Memo

Date: 12 June 2018

Ref: CT160213

Re: Response to PGL Review Memo Bragg Creek Flood Mitigation Project: Potential Pathways of Effect on Downstream Lands and Waters

PROJECT NAME	BRAGG CREEK FLOOD MITIGATION	PROJECT NUMBER	CT160213
SHEET TITLE	2012 AND EXISTING BANKLINE DELINEATION SUPERIMPOSED ON 1924 AIRPHOTO	FIGURE NUMBER	7.1
		ISSUE/REVISION	A

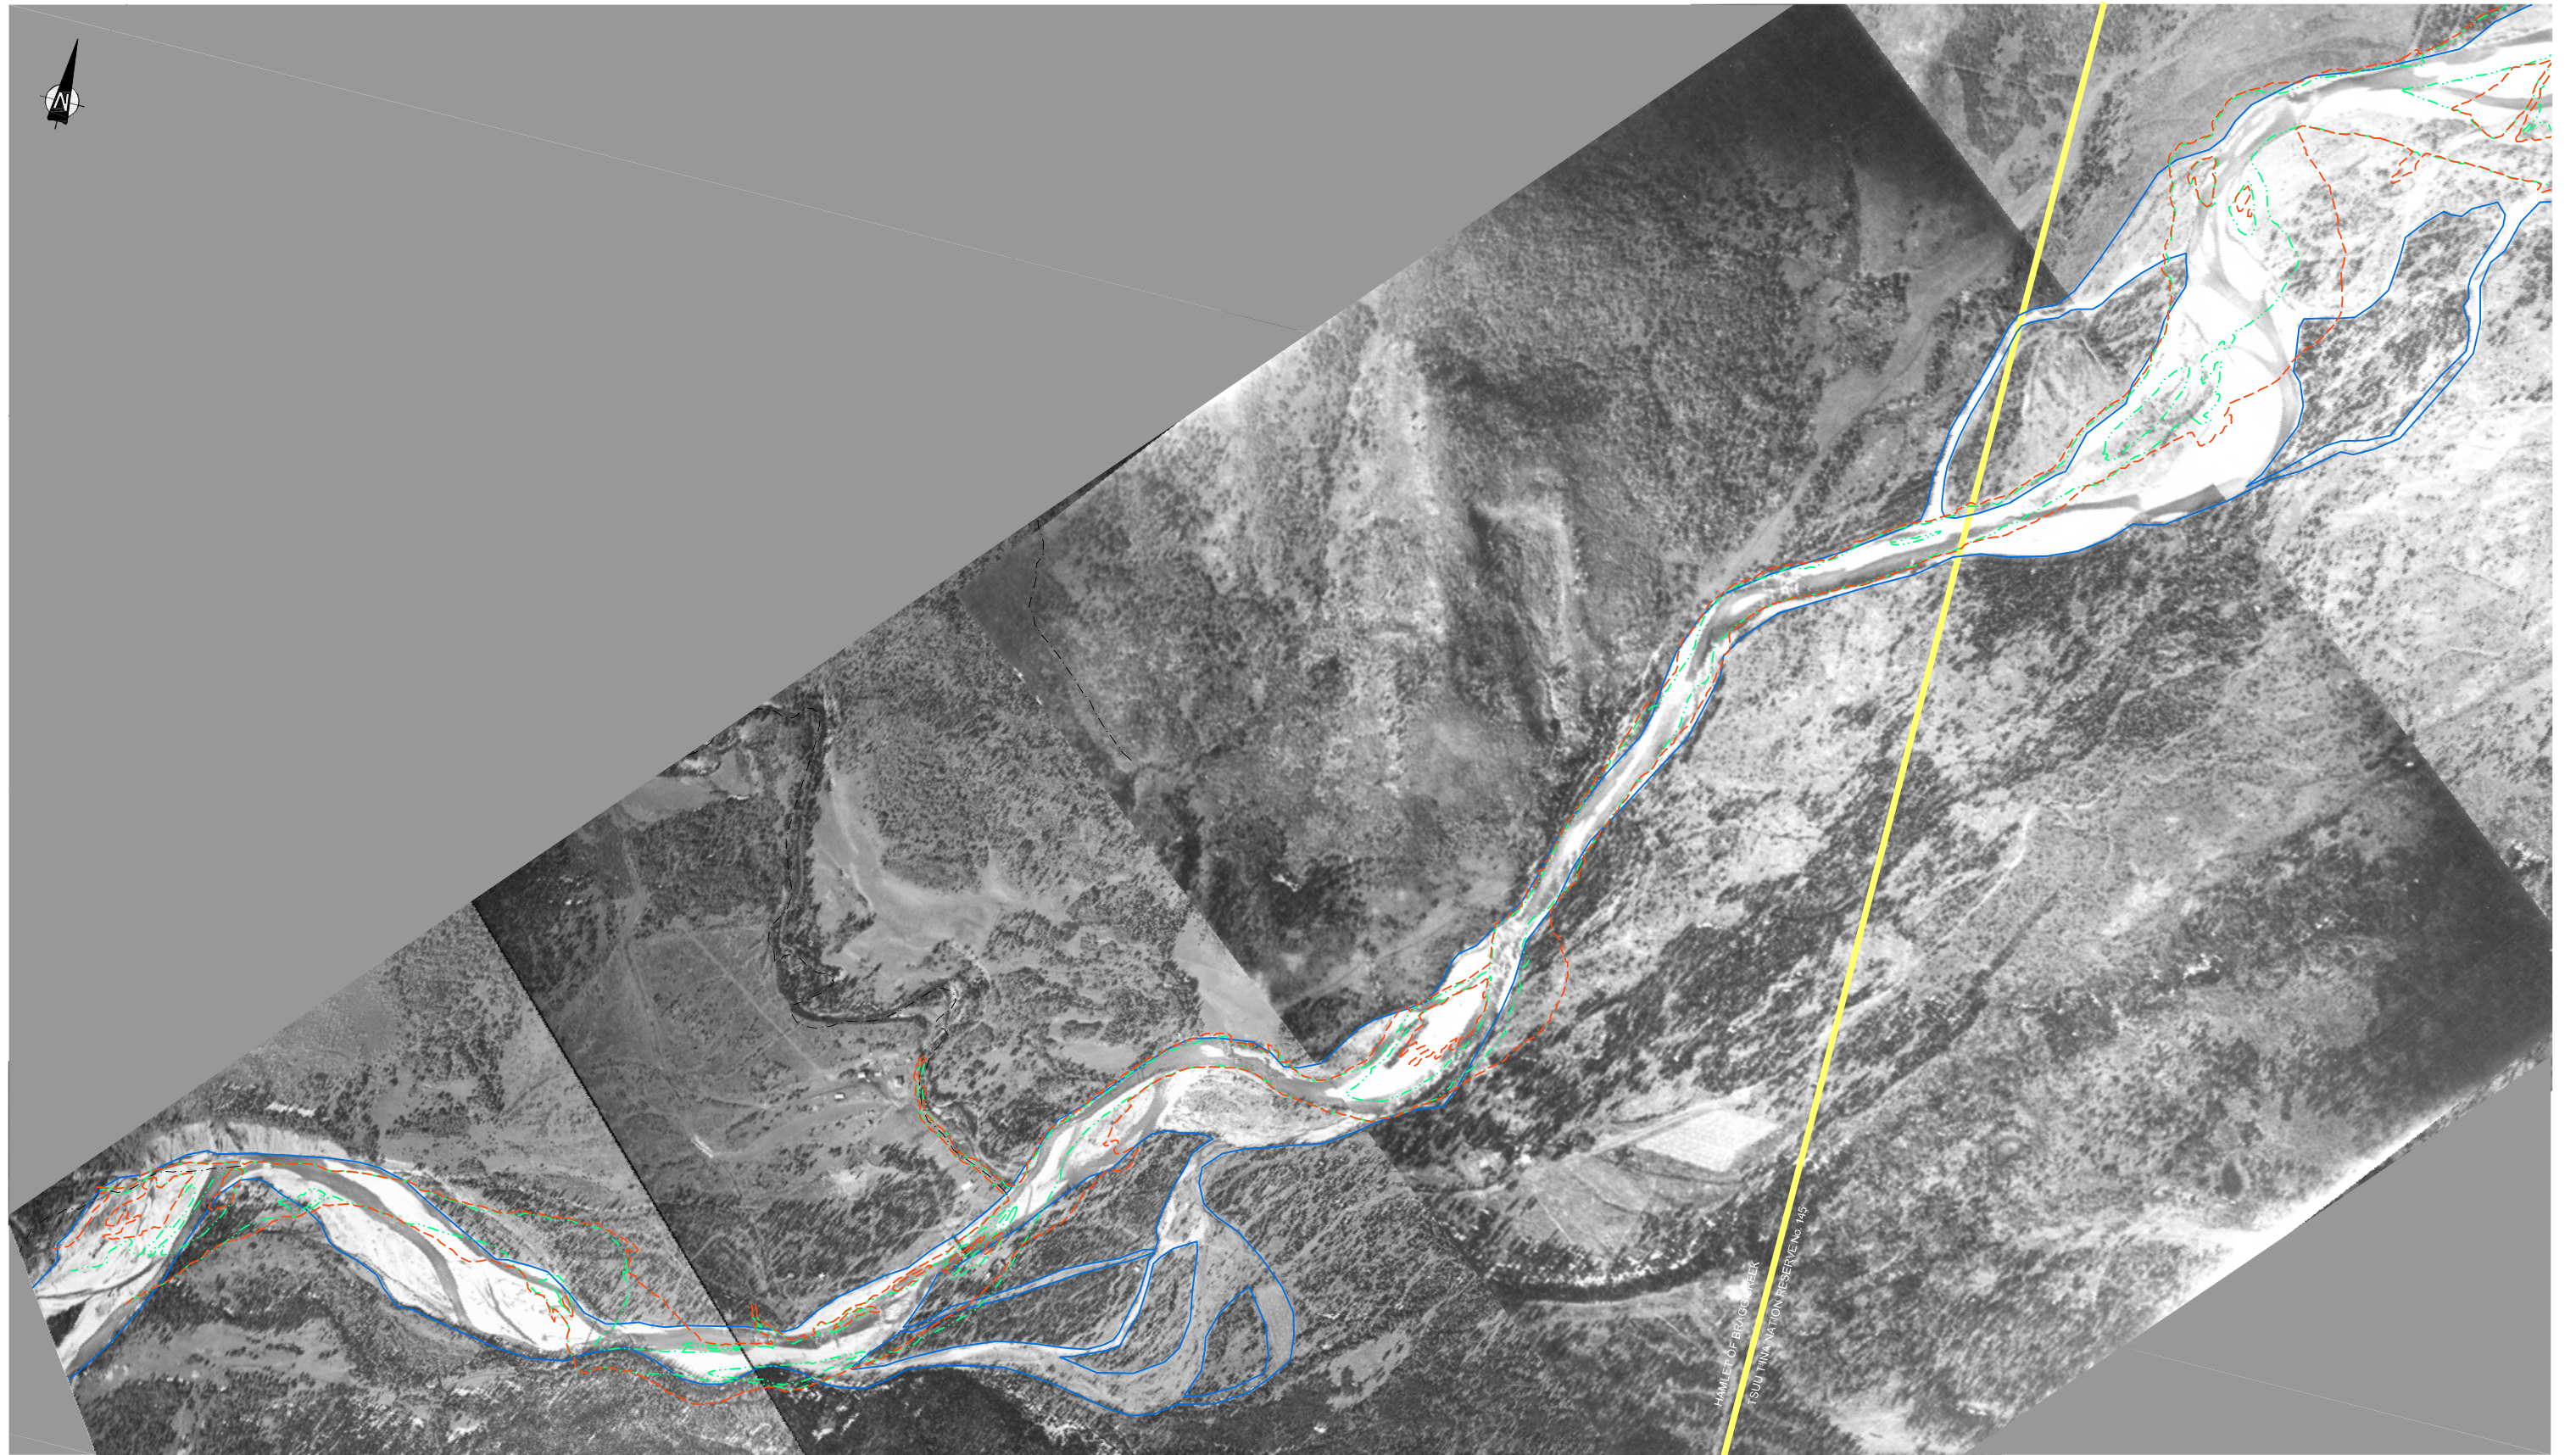
The PGL memo states "Given the increased water velocities predicted to result downstream as a result of the Project it is reasonable to expect that more and/or larger debris may be carried through the project reach to be deposited downstream of the project on Tsuut'ina or other lands. The distance this material may be carried has not been modelled."

For large floods (such as the design event), the increase in water levels and velocities that would occur in the few hundred meters downstream of the boundary is not expected to result in any measurable erosion over and above that which occurs naturally. The attached **Figure 7.1** shows the 2012 and current banklines superimposed on the 1924 airphoto. The 1924 channel was considerably wider and more

braided than the recent configuration. This previous (1924) configuration resulted from the large floods that occurred at the end of the 19th century and early 20th century (see Table 1.1 in the Engineering report). The channel became less braided with a narrower width due to relatively small floods that occurred after 1934, until the large 2013 flood. The channel became more braided and wider due to the 2013 flood, as shown by the comparison of the existing and 2012 banklines. It is within the context of the flood structure impacts being small (see **Table 7.1**), occurring very rarely (for only for a few days during large floods such as 2013) and the natural variability of the channel configurations (see **Figure 7.1**), that the statement is made that the proposed structures are expected to have limited impacts on the current channel morphology of this reach. It should be noted that the proposed barrier system has been set back as far from the main river as possible considering adjacent developments, often in floodplain areas well above normal river levels, and would be high and dry above all but the rare and extreme floods like 2013.

Our response is that during extreme floods, the proposed works will result in considerably less deposition of debris and sediment on the Tsuut'ina land. The 2013 flood resulted in significant erosion of land within the Hamlet of Bragg Creek, which was conveyed downstream. Much of this sediment was deposited in the Tsuut'ina lands. An example from 2013 is provided below:

- One of the major overland flow paths occurring during the 2013 flood was the washout along White Avenue/Hwy 758, in the vicinity of the Trading Post. The volume of land lost at this one site was estimated to be approximately 20,000 m³ (i.e. 2,000 dump truck loads), along a streambank length of 415 m. This estimate is based on the LiDAR Digital Elevation Model (DEM). This was just one site of many where erosion at the Hamlet occurred. This erosion and subsequent conveyance of material onto Tsuut'ina lands would not occur with the proposed structures in place.

PROJECT NAME	BRAGG CREEK FLOOD MITIGATION	PROJECT NUMBER	CT160213
	CLIENT	 ROCKY VIEW COUNTY Cultivating Communities	SHEET TITLE	8.1
			EXTREME FLOOD BREACH INUNDATION EXTENTS AT TSUU T'INA RESERVE AND REDWOOD MEADOWS	ISSUE/REVISION

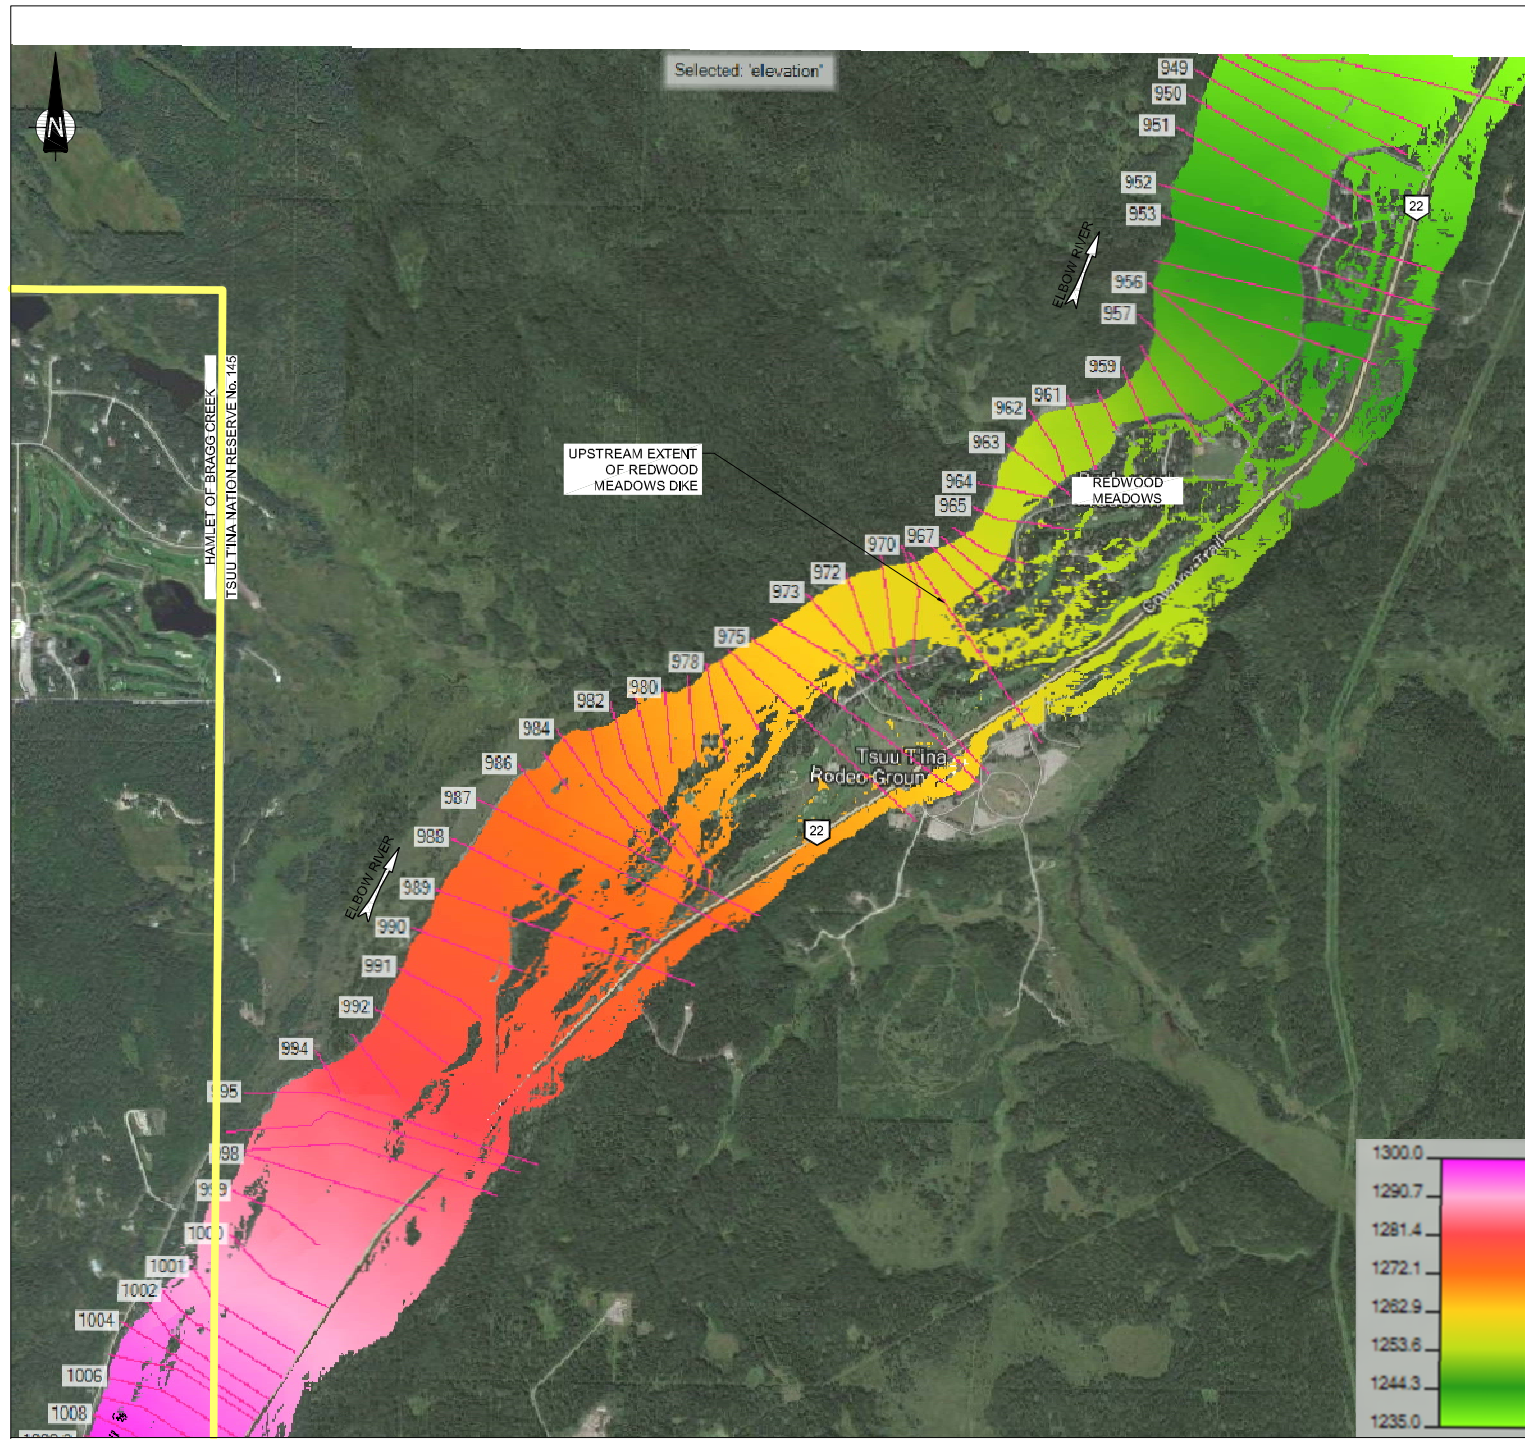
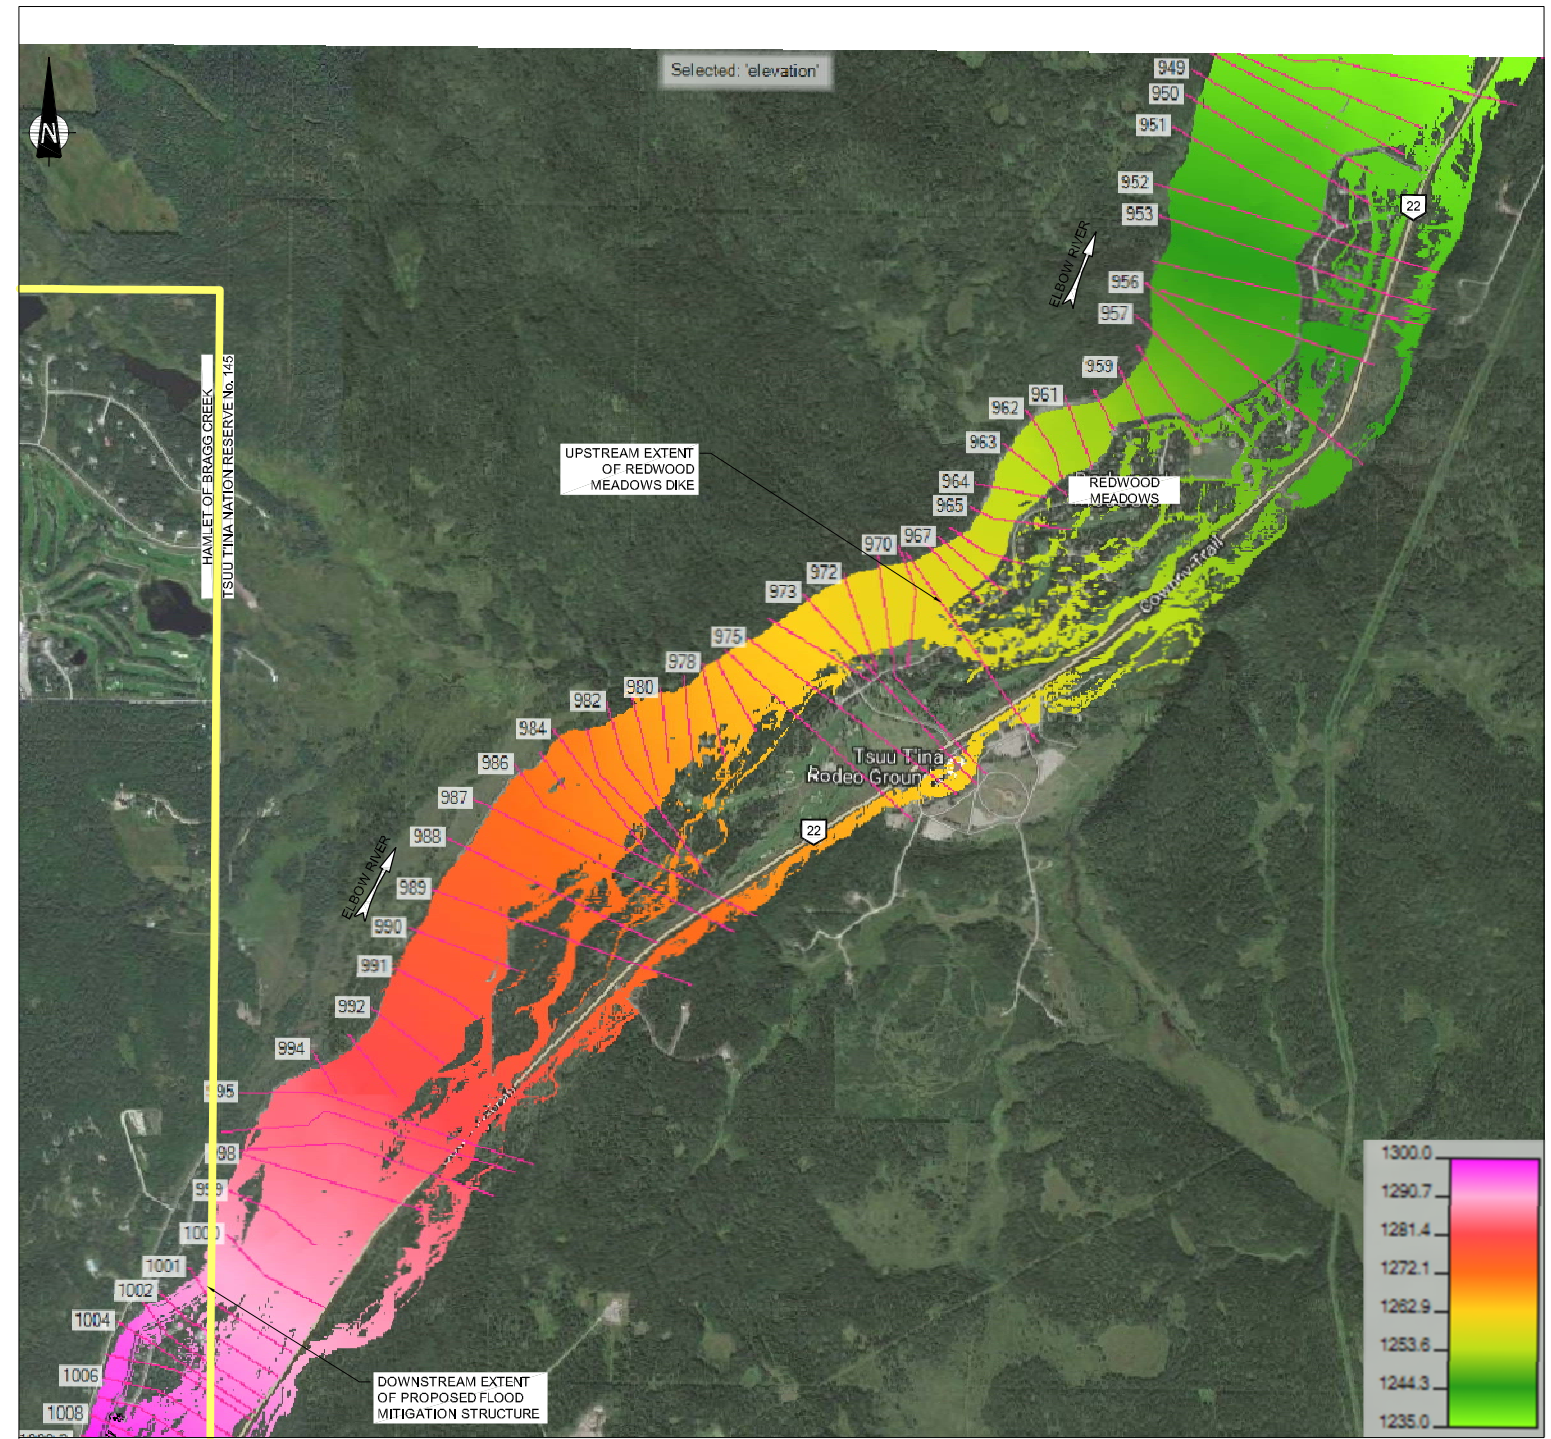
- PGL states that 'spillout leads to widespread flooding'. As shown in **Figure 8.1**, this statement is incorrect as the flow patterns at the Tsuut'ina reserve are generally similar for existing and breach conditions. That is, the breach of the structure leads to overland flooding within the Hamlet which by the time it reaches the Tsuut'ina boundary is generally similar to no breach of flood protection structure conditions. For breach conditions, there is somewhat less overland flooding from the west (upstream) boundary of the Tsuut'ina reserve to the west (upstream) boundary of Redwood Meadows. The flooding extents are similar downstream of the west (upstream) boundary of Redwood Meadows.

- ◆ "Given the increased volume and velocity through the trained section of the river, the river will have greater power and carrying capacity, so will have the ability to move larger debris. In this situation, therefore, debris may reasonably be expected to move downstream and overtop banks as the floodwaters do."

- In the vicinity of the Tsuut'ina boundary, the peak flow rates for no breach and breach conditions are 1248.7 m³/s and 1252.7 m³/s, respectively. This shows there is no significant surge of water due to the breach (these flow rates vary slightly from the 1,300 m³/s because this is an unsteady flow model).

- The channel velocities for both no breach and breach conditions are similar downstream of the Hamlet/Tsuut'ina boundary. Hence, the following statement from PGL is incorrect.
